EAST COUNTY SUBSTATION PROJECT MINOR PROJECT REFINEMENT REQUEST FORM

Date Submitted:	06-27-13	Request #:	5
Date Approval Required:	07-11-13	Landowner:	[This information has been redacted due to its confidential nature]
APN:	[This information has been redacted due to its confidential nature]		
Refinement from (check all that apply):			
<input type="checkbox"/> Mitigation Measure	<input type="checkbox"/> APM	<input checked="" type="checkbox"/> Project Description	<input type="checkbox"/> Drawing
Identify source (mitigation measure, project description, etc.):			
<p>Pages B-15 through B-17, B-26 and B-27, and Figures B-14 A of Section B. Project Description of the Final Environmental Impact Report/Environmental Impact Statement (EIR/EIS) for the East County Substation Project (Project) describe and depict the Boulevard Substation rebuild site and the temporary and permanent footprints associated with construction of the substation. The information in this Minor Project Refinement (MPR) request describes proposed refinements associated with the Boulevard Substation rebuild site based on final Project design. A description of the refinements is provided on page 2 of this MPR request.</

ATTACHMENT C: BOULEVARD SUBSTATION SITE COMPARISON MAP

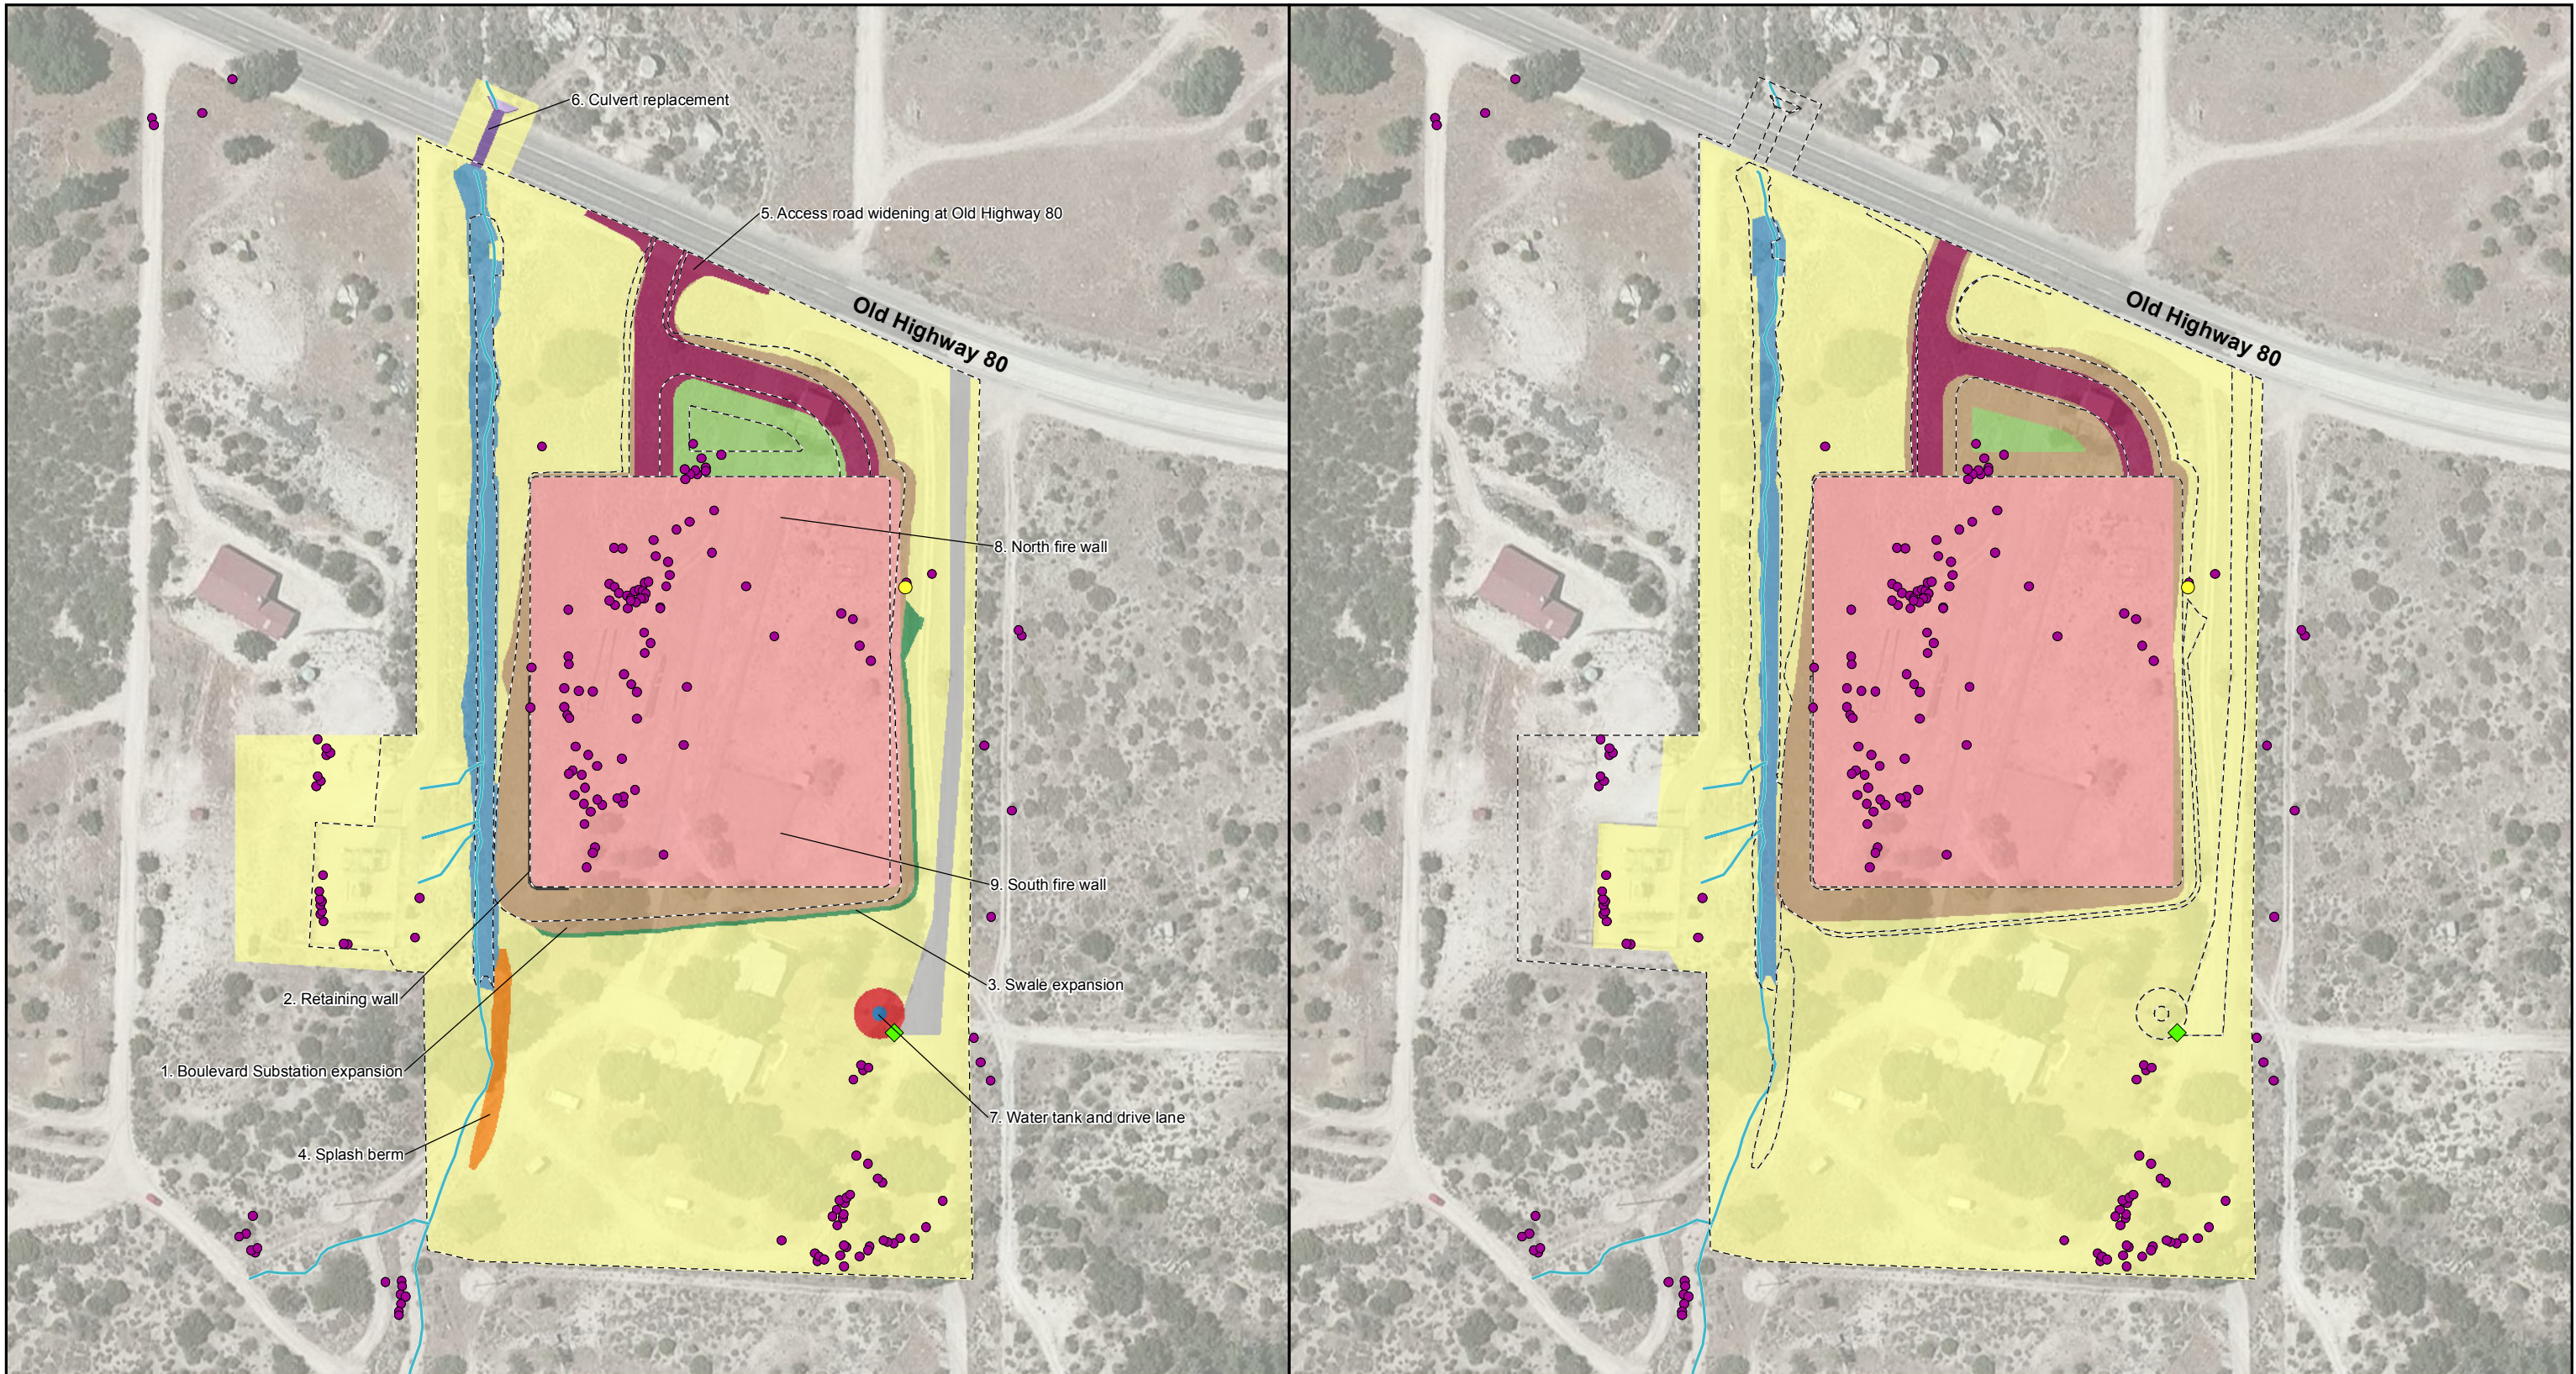
The retaining wall will have a maximum height of approximately 7.5 feet and will be installed along approximately 205 feet of the western side, wrapping around the southern side of the Boulevard Substation rebuild site, as shown in Attachment C: Boulevard Substation Site Comparison Map. The retaining wall is proposed to be a block-gravity wall manufactured by Inter-Block Retaining Systems. Its surface will be treated such that it will blend in with the surrounding landscape, in accordance with the Project's Surface Treatment Plan.

The existing swale located along the western edge of the site will be expanded and widened further. The sides and bottom of the swale will be graded and improved with a pervious grass and concrete-block lined system to create a semi-naturalized channel. An engineered earthen splash berm, located in the southwestern quadrant of the property, as shown in Attachment C: Boulevard Substation Site Comparison Map, will also be constructed. The splash berm will measure approximately 14 feet by 180 feet and will be approximately three feet high. In addition, a new culvert will replace the existing undersized culvert under Old Highway 80 where the swale crosses under the road. Rip-rap will also be installed in the swale on the north side of the culvert.

Curb and grade improvements to the substation's access road design will include widening the access road at its intersection with Old Highway 80.

The fire walls will be constructed on drilled-shaft piers either out of prefabricated panels or poured-in-place concrete. The dimensions of the fire walls will be such that the vertical height will extend three feet above the highest oil-containing part of the transformers, and one foot wider than the containment pits at each end. The approximate dimensions of the southern fire wall, to be installed for the 138/69 kV transformer will be 41.25 feet wide by 28.25 feet tall. The approximate dimensions of the northern fire wall, to be installed for the 138/12kV transformer, will be 37.25 feet wide by 17.25 feet tall. The walls will be located on the north and south sides of the substation between the transformers and the substation fence. The surface of the fire walls will be treated such that it will blend in with the surrounding landscape, in accordance with the Project's Surface Treatment Plan.

The water tank will have a capacity of 16,900 gallons of water, and will be stationed at the southeast corner of the Boulevard Substation rebuild site along the existing access road on the east side of the property. An approximately 12-foot-wide drive lane, surfaced with Class II base, will be built around the water tank for access. Class II base will also be installed over the existing access road to accommodate safe access for fire trucks to the water tank. The water tank will measure approximately 12 feet in diameter and 17 feet in height. The exterior surface of the water tank will be treated such that it will blend in with the surrounding landscape, in accordance with the Project's Surface Treatment Plan.

A list of refinements and the reason for them is included in Attachment F: Refinements Table. In summary, the expansion of the permanent footprint along the southern and eastern sides of the Boulevard Substation rebuild site is needed to implement final engineering and slope stabilization requirements. The initial design was developed with 1.5-to-one cut slopes. As the design evolved, the 1.5-to-1 cut slopes proved not to provide the necessary stability against erosion and failure; therefore, the cut of the slopes will need to be constructed at a shallower two-to-one ratio to reduce erosion and instability. The slope stabilization improvements will require an extension of the permanent footprint by approximately 10 feet on the south and east cut slopes of the substation. Due to the existing drainage swale on the western edge of the substation site preventing an expanded footprint, a retaining wall will be constructed to allow for the slope to be developed at a two-to-one ratio.

The proposed drainage swale widening along the western edge of the Boulevard Substation rebuild site is required to accommodate a partially vegetated lined system. This system is necessary to accommodate the calculated high velocity of storm water flow during a 100-year storm event. The final hydrology analysis of the Boulevard Substation rebuild site indicated that an engineered splash wall or berm will be required across the southwest quadrant of the property to direct off-site storm water flow into the drainage swale located along the west side of the site. An existing earthen berm is located in the general area of the proposed berm; however, it is undersized and does not meet 100-year storm event design requirements. The proposed berm will maintain the pre-existing surface storm water flow pattern and prevent flooding of the Boulevard Substation rebuild site during a 100-year storm event.

The existing culvert that crosses Old Highway 80 is undersized and does not meet current County of San Diego (County) standards and design requirements. The County requires the culvert be designed and constructed to accommodate a 100-year storm event to reduce the potential for impacting Old Highway 80 with flooding or creating erosion at downstream properties.

The proposed widening of the access road at its intersection with Old Highway 80 is necessary to meet San Diego County curb/grade permit standards for width, taper, and radius of the road apron. The final access road design is currently undergoing County review.

The two fire walls are being installed to increase public safety in the event of a transformer fire. The fire walls will increase protection in the event that someone from the public is on the property and near the fence when a transformer fire occurs. The water tank to be installed on the southeastern portion of the property is also being implemented to increase public safety. The water tank is required to implement the Project's operational Fire Protection Plan (FPP). In accordance with Section 4a of the FPP, the water tank is necessary for use on potential
